# COKER'S CORNER ENTRY GATE

Exhibit A

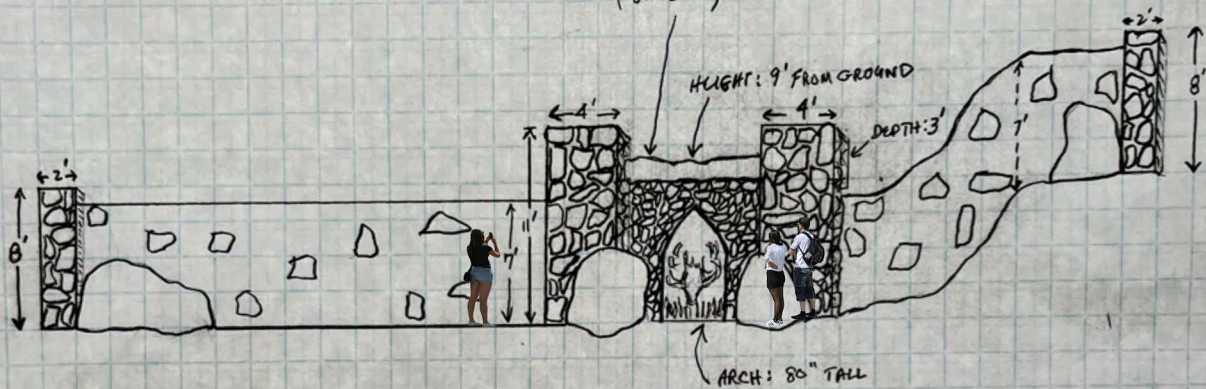
★ PLEASE NOTE THAT VS. THE ORIGINAL PROPOSAL (PLANNING COMMISSION),  
THE WALL ITSELF HAS BEEN LOWERED FROM 10' TO 7' = 3' LOWER;  
THE TOWERS HAVE BEEN LOWERED FROM 14' TO 11' = 3' LOWER.

THIS WILL ALSO ENABLE US TO USE THE HUGE ROCK WE HAVE  
PURCHASED FOR THIS PURPOSE.
